PCN	Product Change Notification	De-23-03-0675	
Product	M8/M12	Date of Publication:	
		29.03.2023

**Title:** M12 male housing adaption of pick and place area

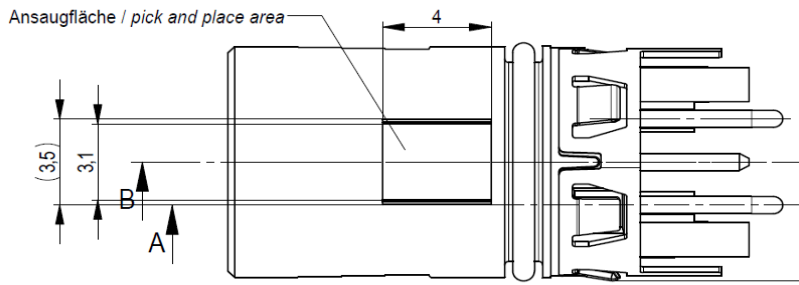
Valued customer,  
to improve the process stability in the molding process we have made a slight design change regarding the pick and place area on M12 male connector housings:

OLD (3.5mm)

New (3.1mm)

This change will be operated without partnumber change, will not affect reliability of product and has no impact on fit or function. Affected connectors you can find under Part.-No.
